STAFF ANALYSIS

CASE NO.:	Z-26-1248021	File ID #: 2026-0452
Address:	2697 Kelly Lake Road, Decatur, GA 30032	Commission District: 3 Super District: 6
Parcel ID(s):	15 137 02 004	
Request:	Application of Tori Engineering c/o Amber Lee to rezone property from R-75 (Residential Medium Lot-75) zoning district to R-60 (Residential Small Lot-60) zoning district to allow twelve (12) single-family homes.	
Property Owner(s):	Richard Panier, Lexer Capital	
Applicant/Agent:	Amber Lee, Tori Engineering	
Acreage:	3.76	
Existing Land Use:	Suburban	
Surrounding Properties:	North: R-75 (Residential Small Lot-75) South: MR-2 (Medium Density Residential-2) East: R-75 West: R-75	
Comprehensive Plan:	Suburban	Consistent X Inconsistent

STAFF RECOMMENDATION: APPROVAL WITH CONDITIONS.

SITE PLAN
SCALE: 1" = 30'

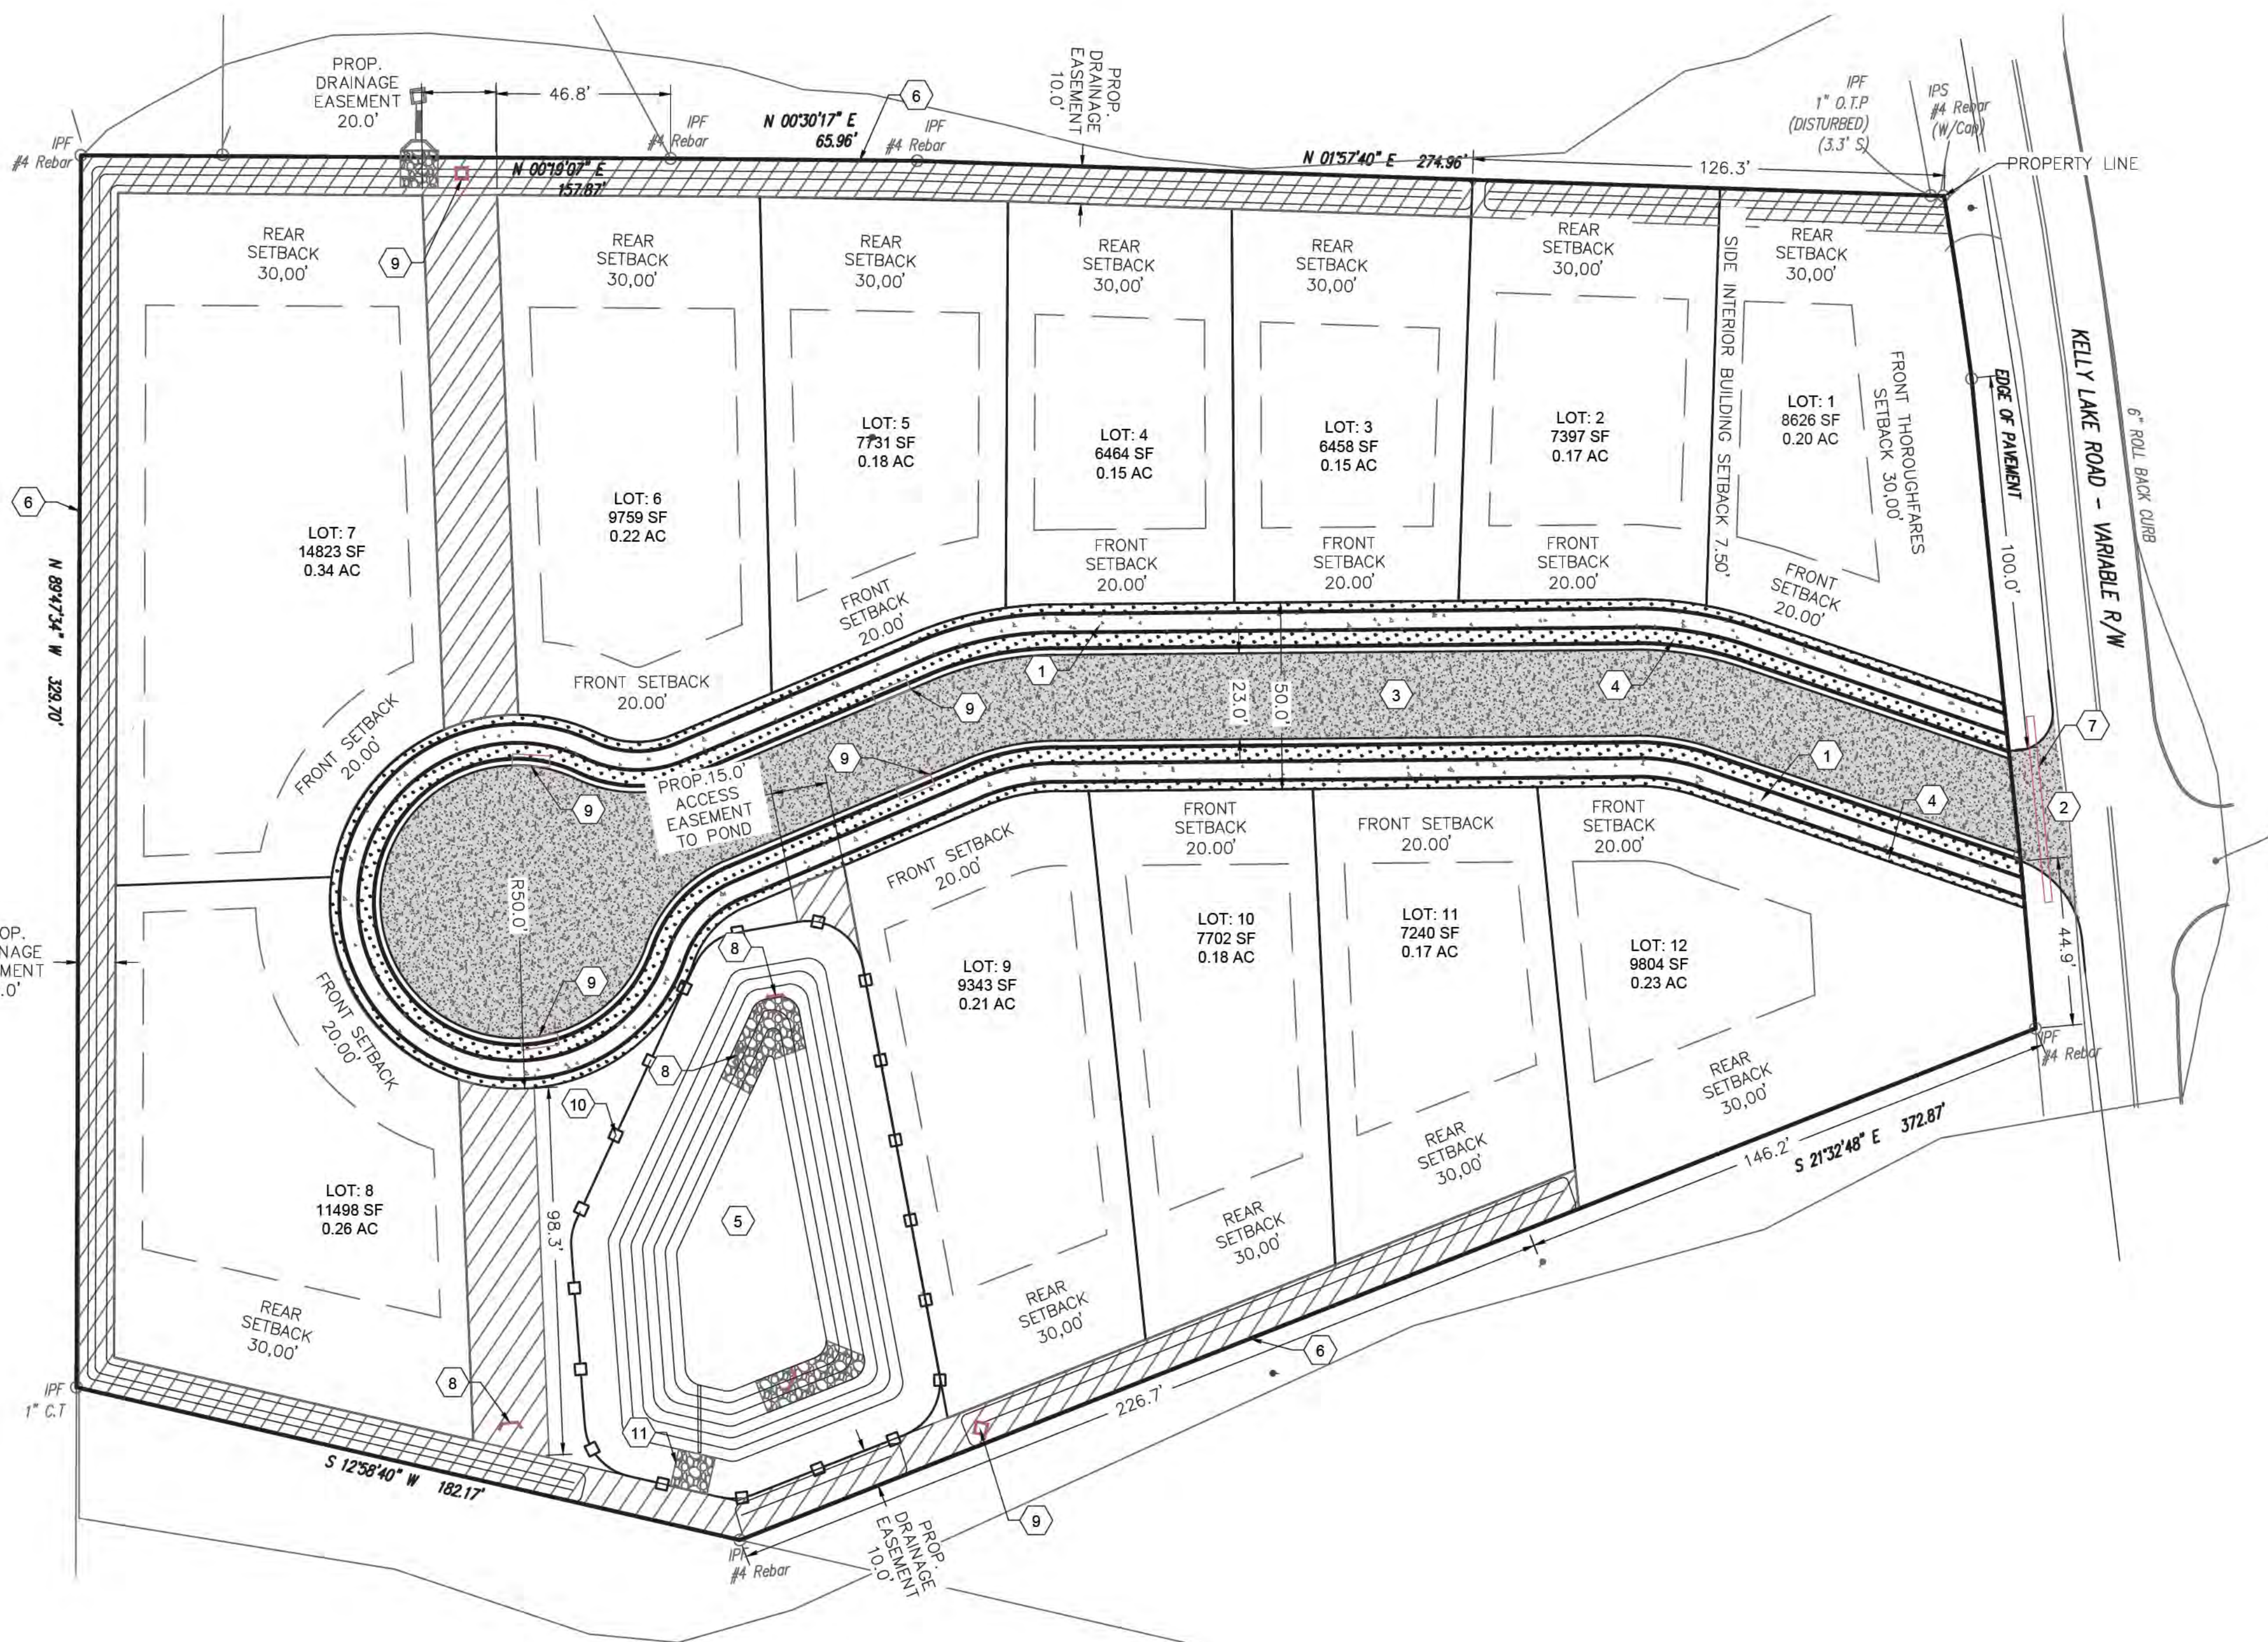
The proposed development meets the dimensional requirements of the R-60 zoning district in accordance with Section 2.2.1. However, while the applicant acknowledges the applicability of Section 5.4.3 (*Streetscape elements and dimensions*), the submitted site plan ("C4-0," dated January 26, 2026) does not clearly demonstrate compliance. Specifically, the plan does not depict required streetscape components, including a

sidewalk along Kelly Lake Road, a landscape strip along the frontage, and street trees along Kelly Lake Road and within the frontage of each proposed single-family lot.

1. Units #1 and #12 shall have a direct sidewalk connection from each unit to Kelly Lake Road.
2. All proposed units’ facades should include a porch.
3. Stormwater retention pond will include at least two (2) benches and will be landscaped. The Applicant will supply proposed enhancements to the retention area prior to Rezoning Approval Letter.

6. Streetscape improvement(s) along Kelly Lake Road shall meet the requirements of *Section 27-5.4.3 (A) Streetscape elements and dimensions (1.) Improvements on new streets (2.) Improvements on existing streets*.
